REMARKS

Docket No. 2973-A-34

AMENDMENTS TO THE DRAWINGS:

3/11

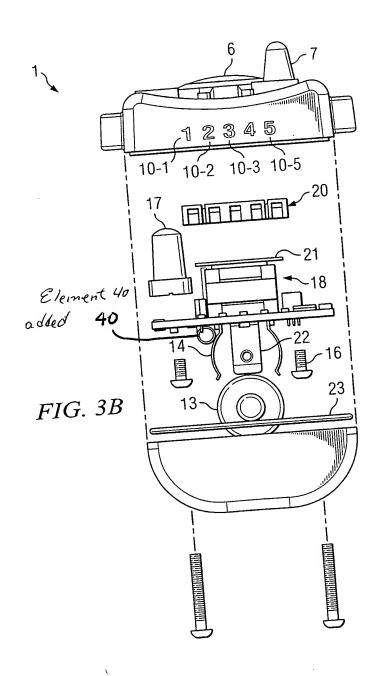
The drawings have been amended to add the reference numeral 40 that had inadvertently

been left out of the drawings. Specifically, the reference numeral 40 was added to Fig. 3B as

shown on the attached copy of Fig. 3B. The addition is shown in red. A replacement of the

The attached sheet of drawings (sheet 3/11) includes changes to Fig. 3B. This sheet replaces the original sheet for Fig. 3B. In Fig. 3B, previously omitted element 40 has been added.
